**Summary Updates for Decommissioning Risk Study
and Comments on NEI Review**

Structural Integrity of Spent Fuel Pool Structures Subject to Heavy Loads Drops

NEI Comments: (Section 3.2.4, page 31 to 36)

**Figure 4 -
risk
ion scheme
NUREG/CR**

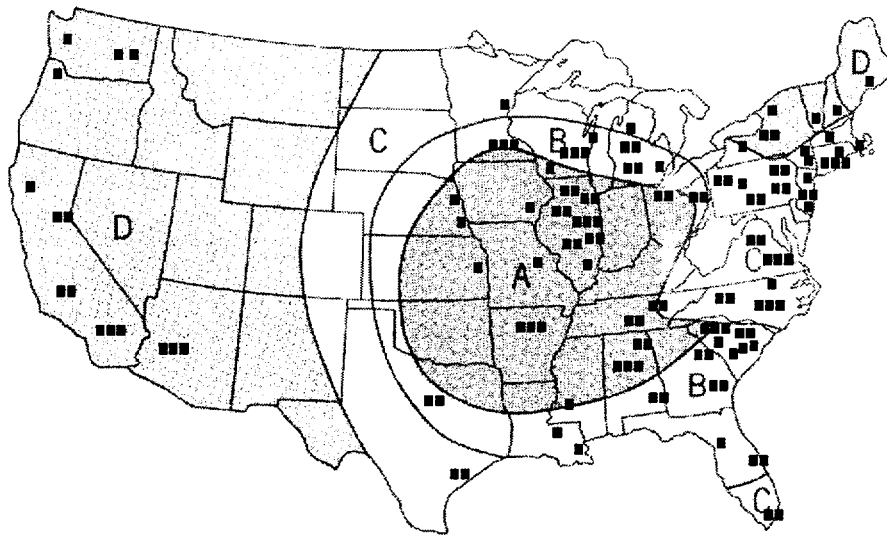
NEI is correct in that the value presented was for the highest tornado region. The exceedance values are best estimate. Because of the rush to release the report, some last minute changes did not get into the draft as released, and 5.6×10^{-7} per year (exceeding an F4) is the correct value. It is appropriate to use a regionalization even if a region (state) has no sites. For example, if Oklahoma is not considered, the value drops to 5.4×10^{-7} per year.

The tornado induced failure of equipment is based on exceeding an F2 (1.5×10^{-5} per year).

The revised report will include the following table and figure to show the regional variations:

**Figure 4 -
risk
ion scheme
NUREG/CR**

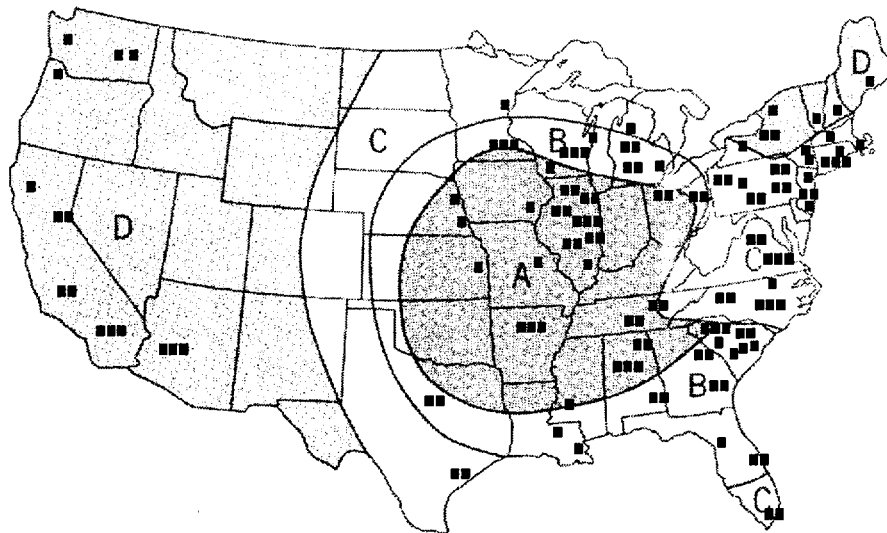
NEI is correct in that the value presented was for the highest tornado region. The exceedance values are best estimate. Because of the rush to release the report, some last minute changes did not get into the draft as released, and 5.6×10^{-7} per year (exceeding an F4) is the correct value. It is appropriate to use a regionalization even if a region (state) has no sites. For example, if Oklahoma is not considered, the value drops to 5.4×10^{-7} per year.

The tornado induced failure of equipment is based on exceeding an F2 (1.5×10^{-5} per year).

The revised report will include the following table and figure to show the regional variations:
